The Planning Inspectorate Ref - APP/Y3615/W/3325573 Guildford Borough Council Ref 22/p/01336

Planning (Listed Buildings and Conservation Areas) Act 1990, Town and Country Planning Act 1990 Appeals by St Edward Homes Site Addresses: Land bounded by the Friary Centre Bus Station, North Street and Leapale Road, Guildford, Surrey, GU1 4PU and 17 North Street, Guildford,

ADS 16-8-2023 2023-8-16 22-P-01336 Comments to Planning Inspectorate

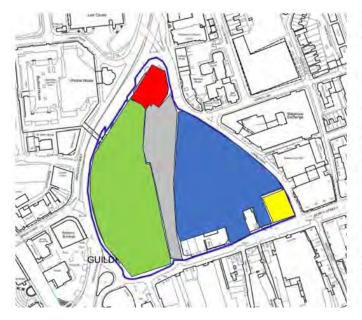
The Society contends that the site is being overdeveloped which is resulting in an unacceptable Mass and Scale.

The Society understands the existing Friary Shopping Centre and No1 Onslow Street (21/P/00539 referred too above) are excluded from the proposed development, the applicant has also failed to obtain ownership of Norwich House and North Street Frontage between commercial road and Woodbridge (which contains Barclays Bank now subject to a planning application 23/P/00984). The planning application thus refers to a restricted site as represented by the blue area.

Red

-No1 Onslow Street
Planning Approved

Green

- Friary Centre

Grey

- Bus Station with parking for No1 Onslow Street underneath.
 Part being used for new public space by North Street Scheme Blue
- North Street Scheme Yellow
- Norwich house
 Planning application submitted.
